TECHNICAL BULLETIN

FAM-A-0106-A

Change in Indication of Place of Origin for the FX Configurator-FP

2.1 Change in Packaging Box

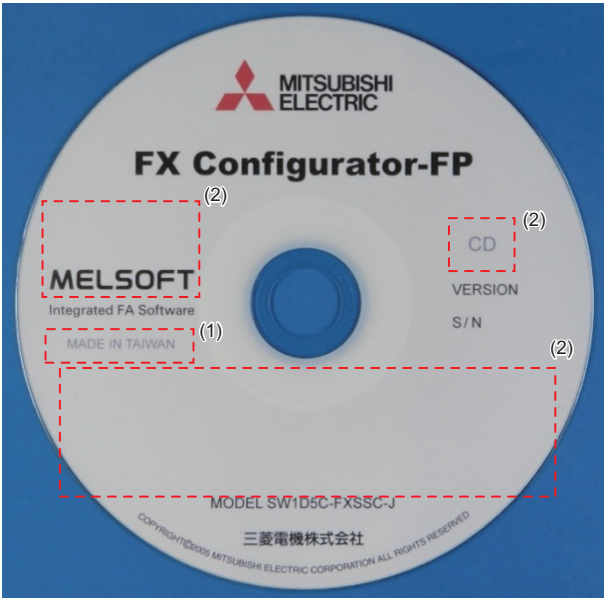
Before change	After change	Details on the change
		<p>The following items will be added.</p> <p>(1) Pictorial marking for handling</p>  <p>(2) Place of origin, certificate of qualification</p>  <p>(3) QR code</p> 
		<p>(4) Place of origin</p>  <p>(5) Recycling symbols</p>
